Debonair Limited Unit-2 (Extension)

Plot # 356, Shorifpur, Ozarpara, National University, Joydebpur, Gazipur.

9 April-2023

Observations

Observation: Dining & Canteen Shed

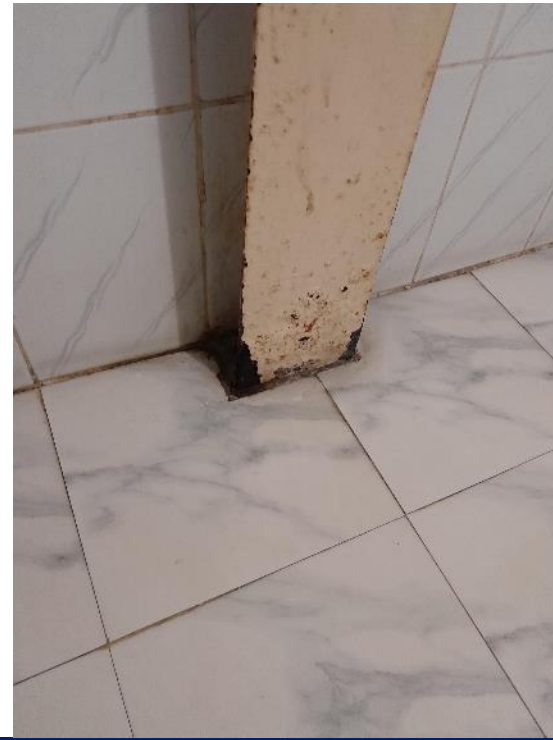
Gap between connection plates

Connection gap found between steel connection plates of rafter. Building engineer is required to fill all the steel connection gap with suitable method.

Steel column out of plumb

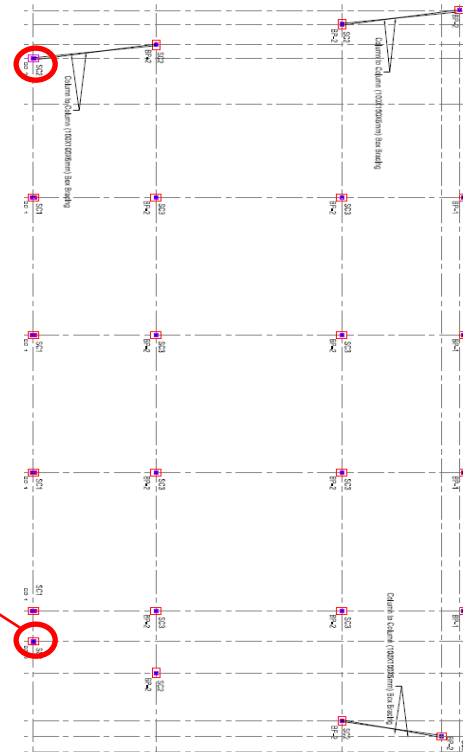
Steel column out of plumb

Indicated column was found vertically inclined which may occur due to poor fabrication work. Building engineer is required to check the column alignment and suggest necessary alternatives.
